<b>Title - Sujet</b> REPLACEMENT HF MONITOR RECEIVERS	
<b>Solicitation No. - N° de l'invitation</b> W8474-136566/B	<b>Amendment No. - N° modif.</b> 007
<b>Client Reference No. - N° de référence du client</b> W8474-136566	<b>Date</b> 2014-01-13
<b>GETS Reference No. - N° de référence de SEAG</b> PW-\$\$QE-450-24137	
<b>File No. - N° de dossier</b> 450qe.W8474-136566	<b>CCC No./N° CCC - FMS No./N° VME</b>
<b>Solicitation Closes - L'invitation prend fin</b> <b>at - à 02:00 PM</b> <b>on - le 2014-02-03</b>	<b>Time Zone</b> <b>Fuseau horaire</b> Eastern Standard Time EST
<b>F.O.B. - F.A.B.</b> <b>Plant-Usine:</b> <input type="checkbox"/> <b>Destination:</b> <input checked="" type="checkbox"/> <b>Other-Autre:</b> <input type="checkbox"/>	
<b>Address Enquiries to: - Adresser toutes questions à:</b> Guilderson, Greg	<b>Buyer Id - Id de l'acheteur</b> 450qe
<b>Telephone No. - N° de téléphone</b> (819) 956-0564 ( )	<b>FAX No. - N° de FAX</b> (819) 956-0740

The following technical questions have been asked by the vendor community and should be recognized for any response(s) to the LOI:

## JTFN

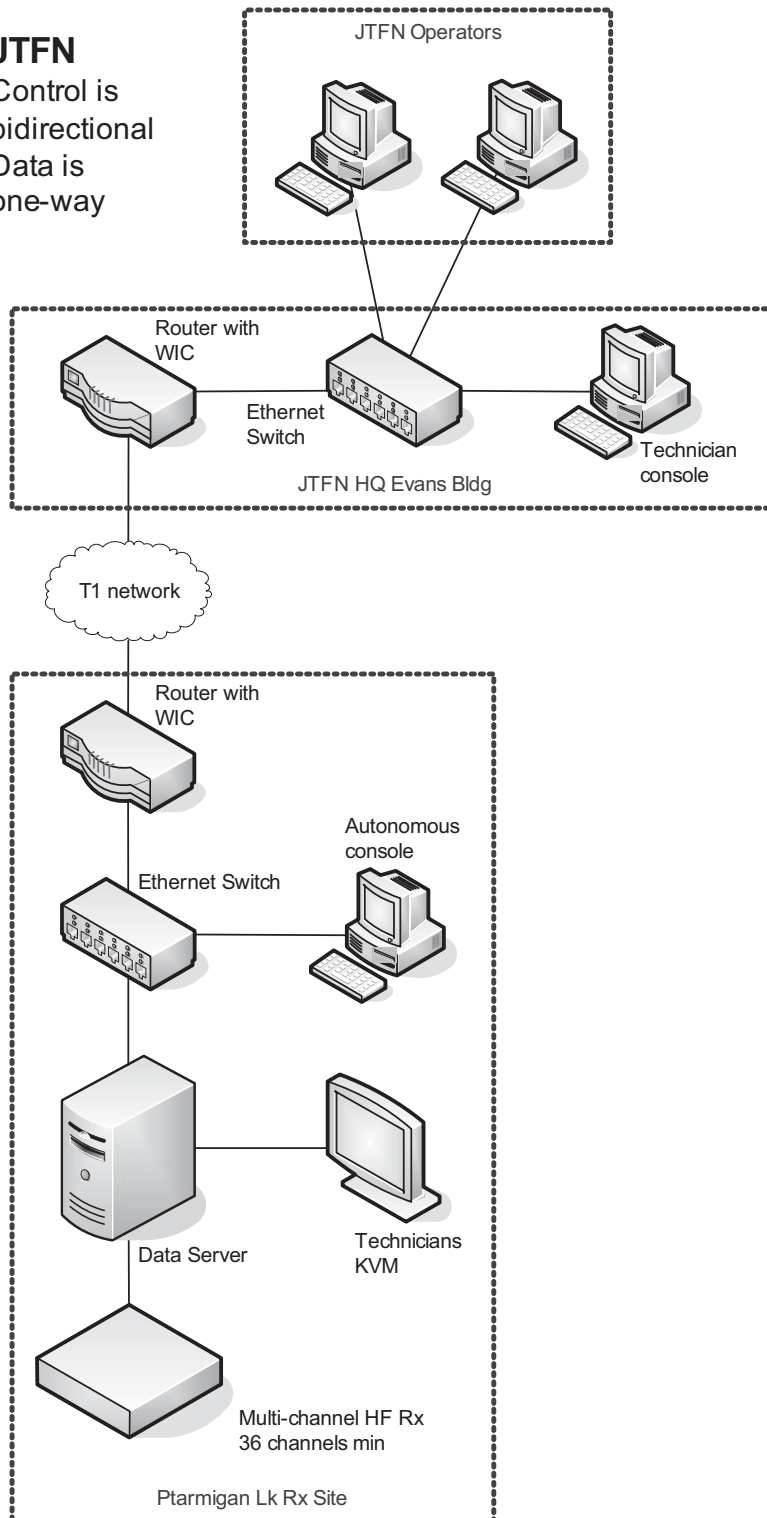
**Notional diagrams are supplied for the MACS and MARCOM system receive sites. Can the Government supply notional diagrams for the JTFN HQ, CFSCE HF Training Facility, and the HF Development Laboratory system receive sites as well? (Appendix 2 Drawings for HF Monitor).**

Yes. These new drawings are included as an amendment to Appendix 2.
